MINERALS PROGRAM INSPECTION REPORT**PHONE: (303) 866-3567**

MINE NAME: Lyons Pit	MINE/PROSPECTING ID#: M-1974-015	MINERAL: Sand and gravel	COUNTY: Boulder
INSPECTION TYPE: Monitoring	INSPECTOR(S): Amy Eschberger	INSP. DATE: March 22, 2017	INSP. TIME: 14:00
OPERATOR: Martin Marietta Materials, Inc.	OPERATOR REPRESENTATIVE: Julie Mikulas, Josh Kruchten	TYPE OF OPERATION: 112c - Construction Regular Operation

Photo 16. View of sediment deposited in Lake 3 by September 2013 flooding.

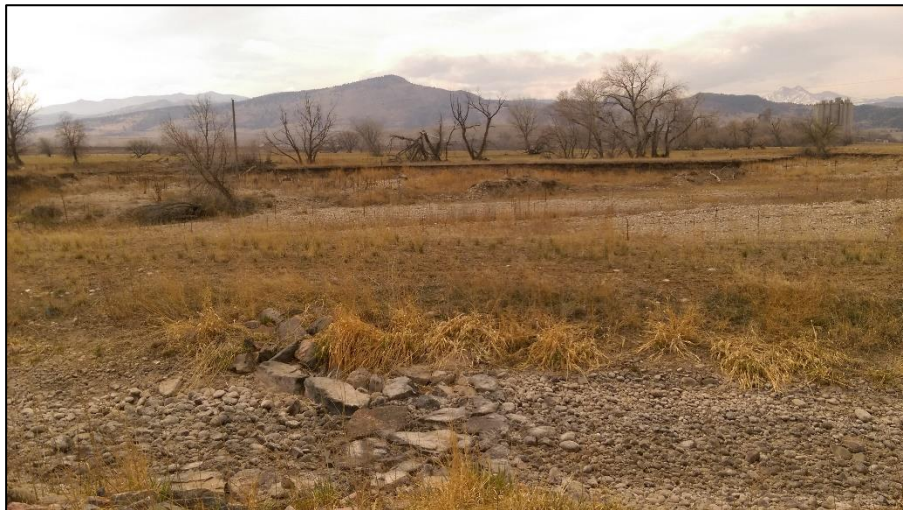
Much of the Lake 3 shorelines were scoured by the flooding, leaving slope gradients of near vertical. The pit was dry during the inspection, with grasses, forbs, and some weeds volunteering across the rocky pit floor (**Photos 16-22**). The operator expressed a desire to mine the rock deposited on the pit floor by the flood. The Division would not object to this activity as it would be consistent with the approved mining plan. However, it should be noted that the approved reclamation plan on file has this pit being backfilled and potentially turned into a public park. This plan could be revised at any time through the submittal of a Technical Revision.

The other problem cited in this report is for the excessive erosion observed on site, particularly along portions of Lakes 2, 3, and 4 shorelines. The Division realizes the lake shorelines had been reclaimed, but were damaged by the September 2013 flooding. However, the Division believes the operator has had a reasonable amount of time to repair this damage. Rule 3.1.6(3) requires all surfaces of the affected land to be stabilized and protected so as to effectively control erosion. The operator will need to repair and stabilize the lake shorelines, grading them to the approved 3H:1V or flatter slope gradient. By the corrective action due date, the operator shall provide photo documentation to the Division verifying this work has been completed. The operator will also need to demonstrate that the current flood protection plan is adequate to protect the site from stream capture and associated flood damage in the future. This may include submitting a Technical Revision to revise the approved mining and reclamation plans to include an updated flood protection plan for the site. The Division recommends the operator consult with Boulder County and Urban Drainage and Flood Control District in developing an adequate flood protection plan for the mine site.

CORRECTIVE ACTIONS: By the corrective action due date, the operator shall provide photo documentation to the Division demonstrating the pond bank erosion has been repaired and the slopes graded to the approved 3H:1V gradient, and the site has been reconstructed and stabilized to prevent erosion damage. The operator shall also demonstrate by the corrective action due date that the current flood protection plan is adequate to protect the site from stream capture and associated flood damage in the future. This may include submitting a Technical Revision to revise the approved mining and reclamation plans to include an updated flood protection plan for the site.

Photo 34. View of flood damage located west of disturbed area but within approved permit area. Note ditch carrying some water during inspection.

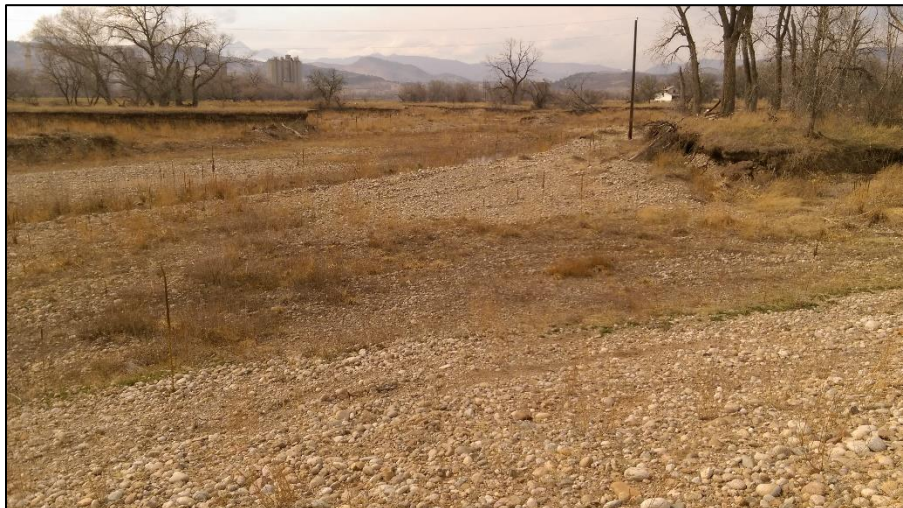
During the inspection, the Division walked northwest up the South Branch, and observed the damage caused to this ditch by the September 2013 flooding (**Photos 33-36**). The flood waters had significantly widened the ditch, leaving washouts with steep banks approximately 4-5 feet in height and depositing a fairly large amount of rocky sediment. The ditch had some minor flow during the inspection. The Division discussed with Ms.

Mikulas and Mr. Kruchten what reclamation responsibility the operator has for the flood damage that occurred west of the disturbed area, but within the approved permit area. The Division informed them that if the land had not been disturbed by the operation prior to the flooding and would not be disturbed by the operation in the future, the operator would not be required to repair the flood damage. However, if any portion of the approved permit area is disturbed by the operation (e.g., haul roads, stockpiling, mining, equipment storage), such land must be reclaimed to its approved post-mining land use. Additionally, if the flood damaged land within the approved permit area in any way reduces the effectiveness of the operator's flood protection and/or stormwater management plans for the site, the damage may need to be repaired and the land stabilized, regardless of whether it was disturbed by the operation.

Close-Up of Disturbed Area Before September 2013 flooding
Red Outline = 610 acres = Approved Permit Area
(Image data from 10/7/2012)

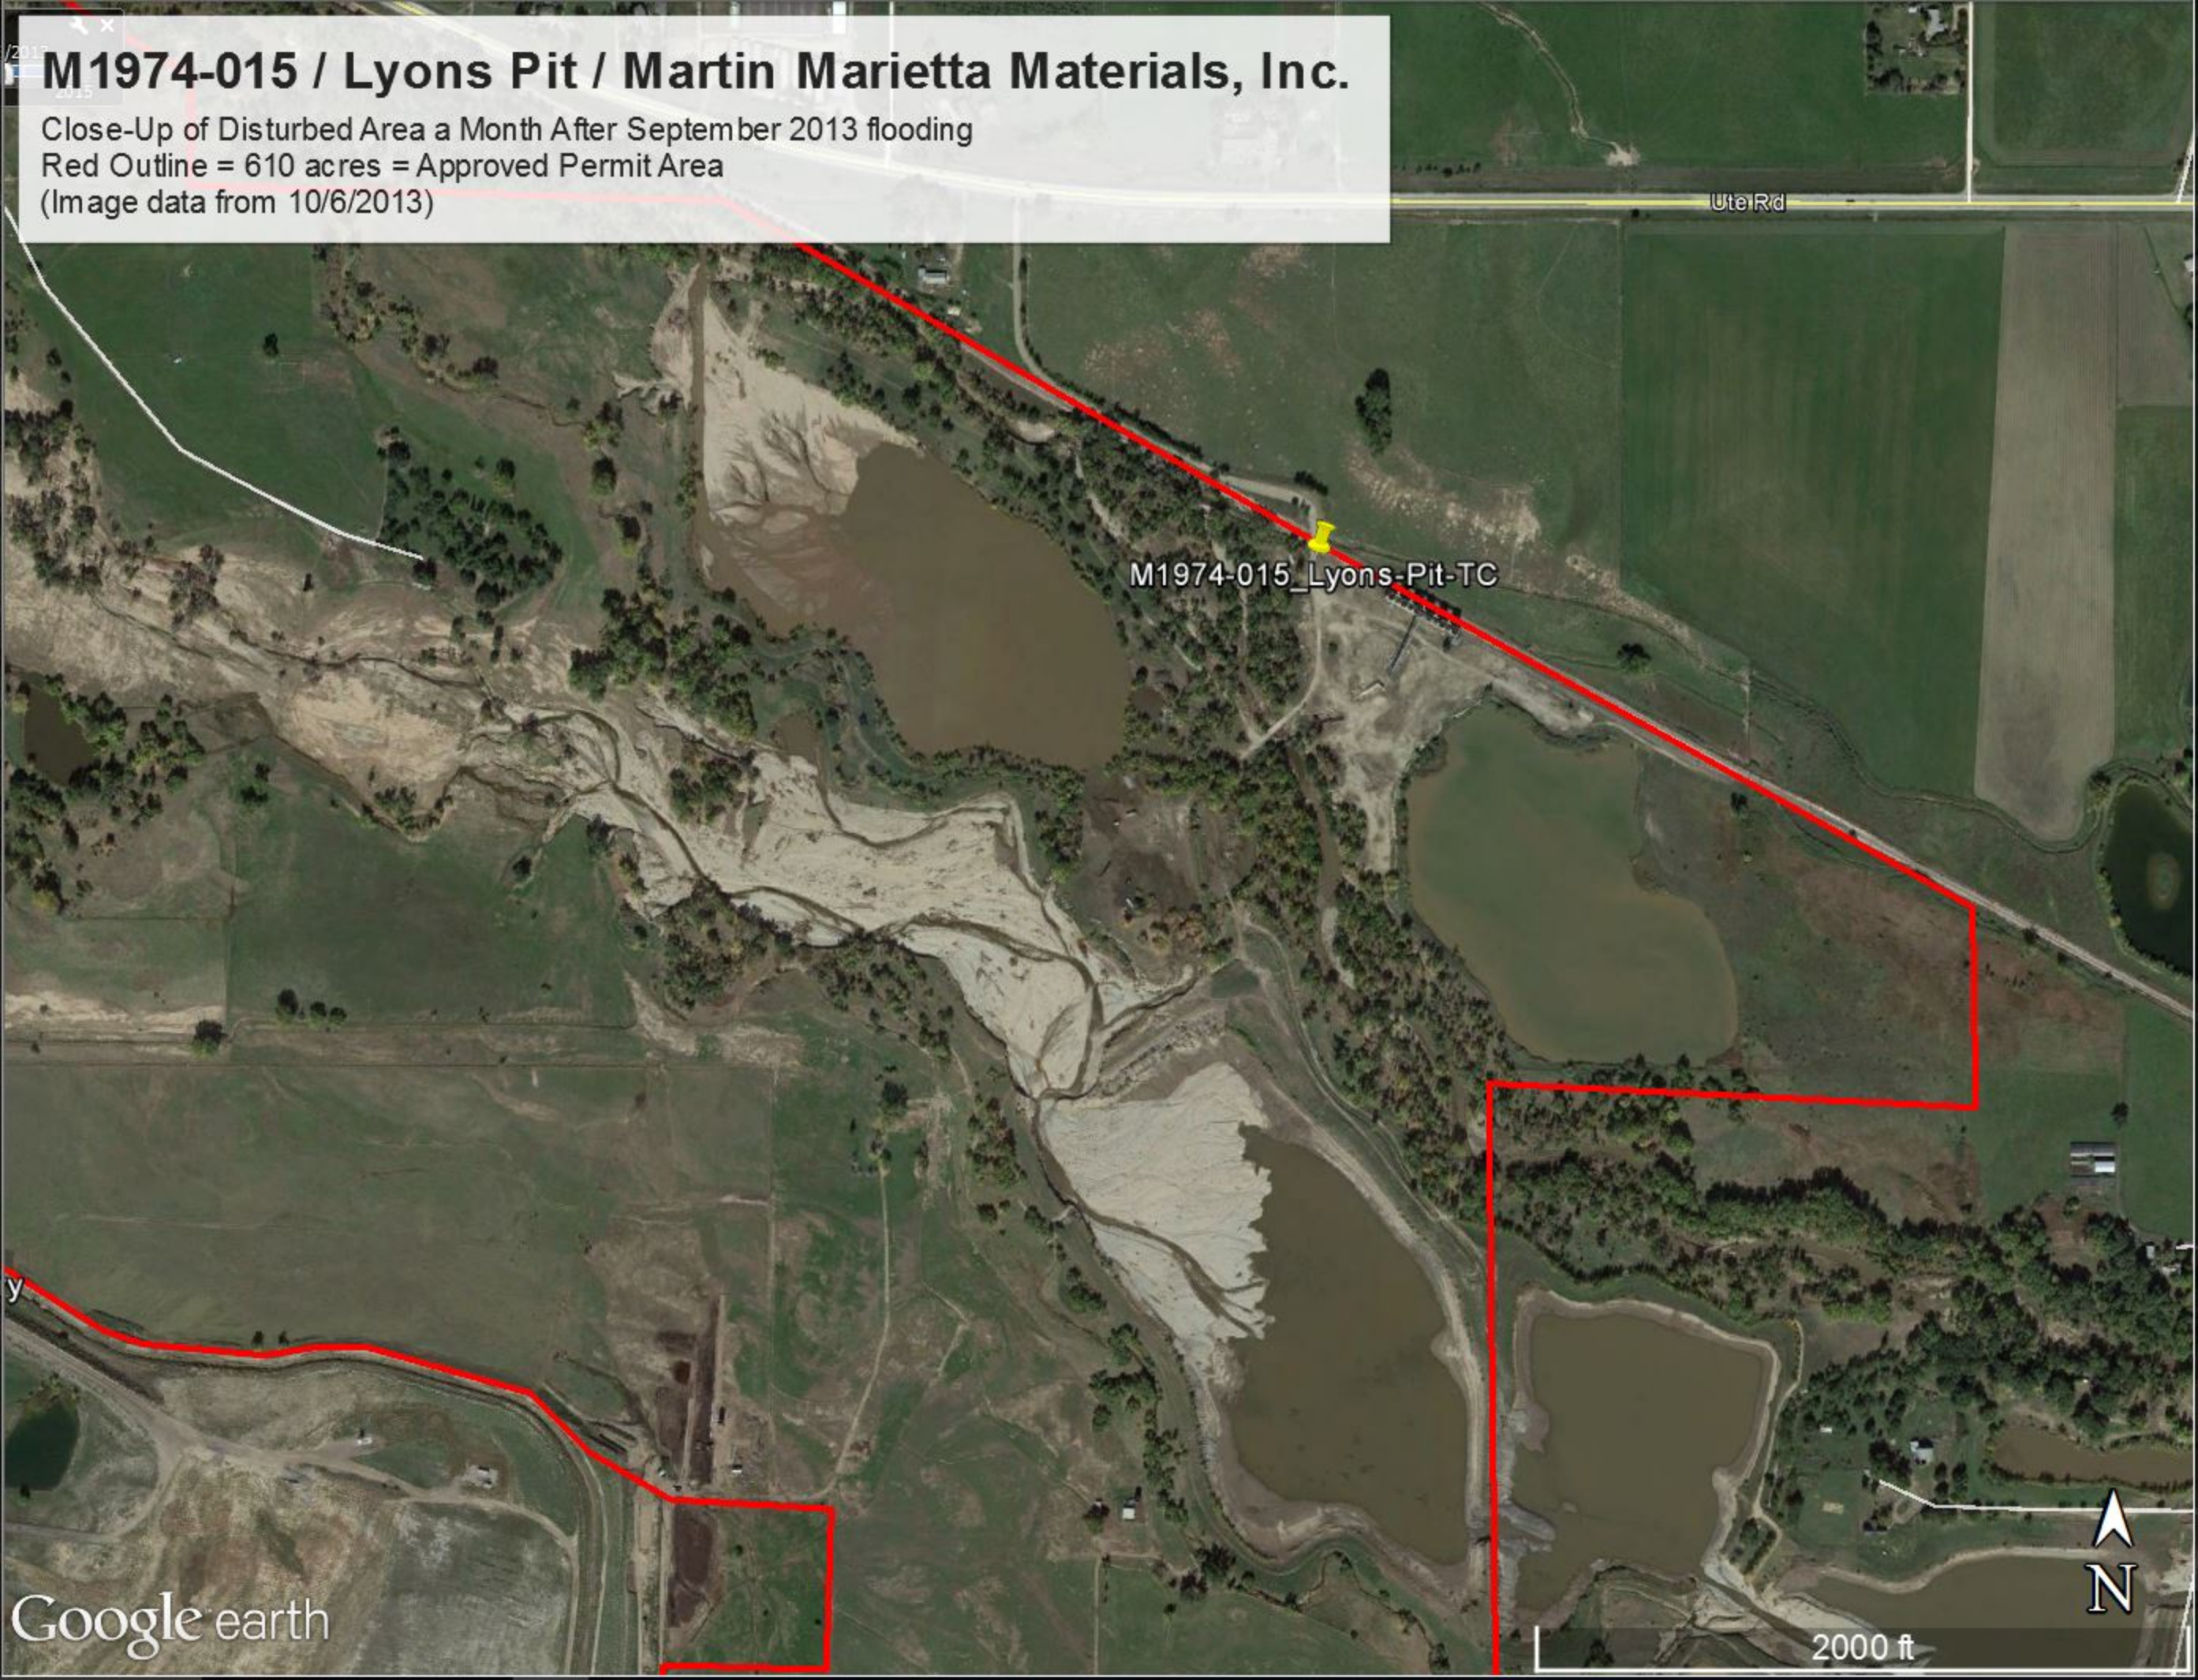
Due to the historic flooding that took place in September 2013, the State of Colorado Office of the Governor issued a total of nine Executive Orders between September 13, 2013 and June 20, 2014 to address the many challenges faced by those affected by the flooding. The second Executive Order, issued on September 19, 2013, authorized several State departments (including the Department of Natural Resources), to suspend the provisions of any regulatory statute prescribing the procedures for conduct of state business, or the order, rules, or regulations of any state agency. Therefore, the Division gave operators of mine sites affected by the flooding some time to assess the damage, repair the damage, and work to protect the site from future flood events. It has now been 3-1/2 years since the flooding occurred, and 2 years, 10 months since the last Executive Order was issued pertaining to the flooding. Therefore, the Division believes that operators have had a reasonable amount of time to repair any flood damage that occurred on their mine site, and to develop or strengthen their flood protection plan.

The Division is citing two problems in this report (see pages 1 and 2) which are associated with damage caused by the September 2013 flooding. One problem is cited for the breached slurry wall around Lake 4. As mentioned above, this lake is no longer considered a sealed reservoir. The operator will need to demonstrate that the site is in compliance with the SEO with regard to exposed groundwater on site, or that the operator is taking measures to bring the site into compliance with the SEO. Once the liner has been repaired, tested, and approved by the SEO, the operator will need to submit to the Division the 90-day performance test final report and the SEO's approval letter. By the corrective action due date, the operator shall provide to the Division an estimated schedule for repairing the damaged portions of the slurry wall.
